NOVA-ANU TARGET HALL  
MEDIUM ENERGY TARGET BAFFLE  
TARGET LEVELING FOOT ROD LONG

SCALE	DRAWING NUMBER	SHEET	REV
2:1	8875.112-MC-433711	1 OF 1	A
CREATED WITH : Ideas12NXSeries		GROUP: ACCELERATOR MECH. SUPPT.

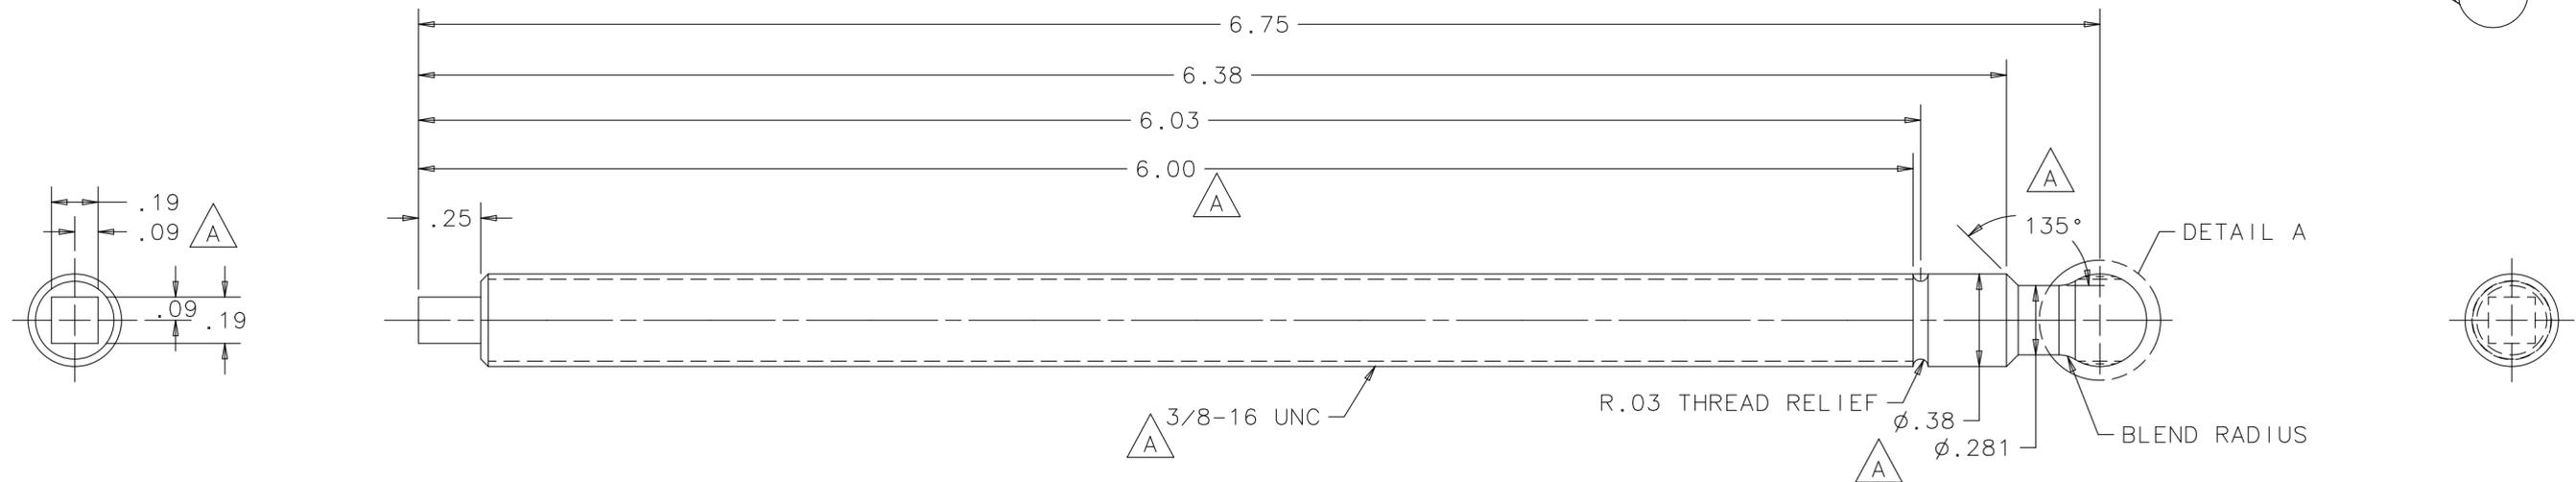
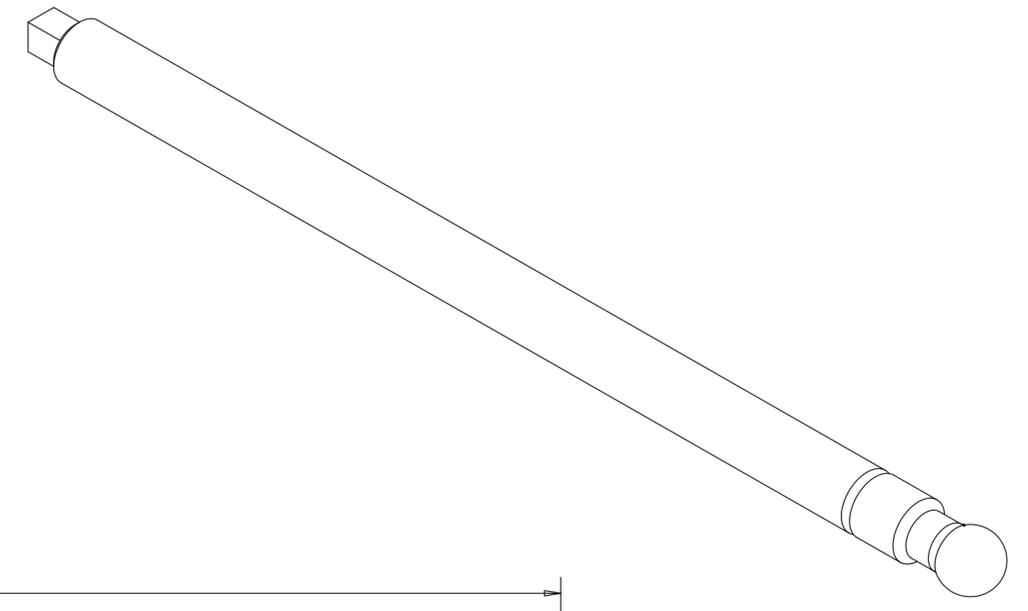
REV	DESCRIPTION	DRAWN	DATE
		APPROVED	DATE
A	3/8-16 UNC WAS 1/4-20 UNC, 3/8-24 UNF WAS 5/16-24 UNF $\phi$ .38 DIM WAS $\phi$ .25, $\phi$ .281 DIM WAS $\phi$ .19, 135° WAS 150°, AND FLATS ADDED	R. STEWART	25-MAY-2011
		M. MCGEE	20-SEP-2011
